### APPLICATION FOR MATERIAL LICENSE

Docket No. 030-03665  
License No. 04-09763-01  
Control No. 70823

This is in reference to the submittal of your application dated December 7, 1988 for renewal of your byproduct material license. In order to complete our review, we need the following additional information:

This is in reference to your letter of March 20, 1989 concerning additional information necessary to complete your review of our byproduct material license.

9B.

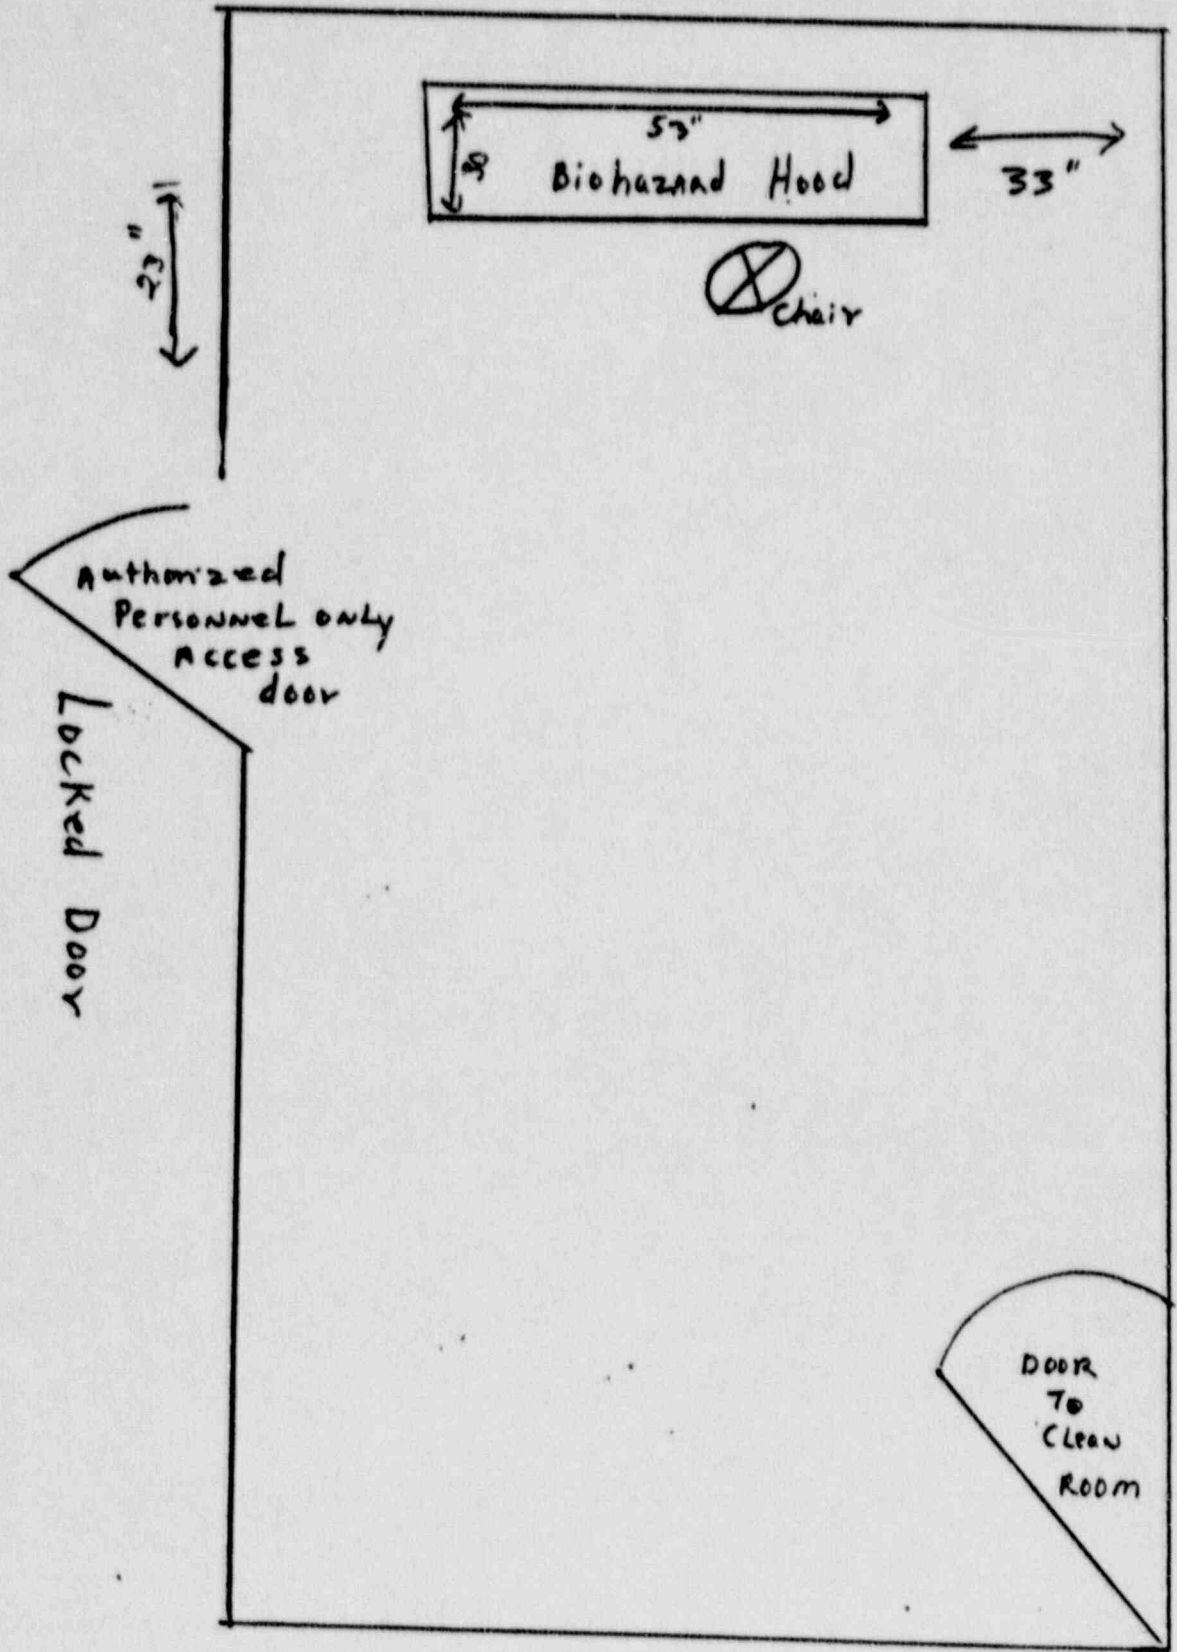
5. Specify the location (e.g. working area or laboratory) of your facility where radioactive materials will be used and stored. A drawing or sketch showing your use and storage locations would be helpful in describing your facility.

5. Item 9 has been rewritten and a drawing of the area attached.
6. Paragraph E 7 of our SOP has been rewritten to provide surveys similar to those of Appendix I.

- b. Phosphorus - 32
    1. Attach Drawings of facilities
    2. The Eberline - 120 with Hand Probe HP-260 will be used to monitor  $\beta$  radiation.
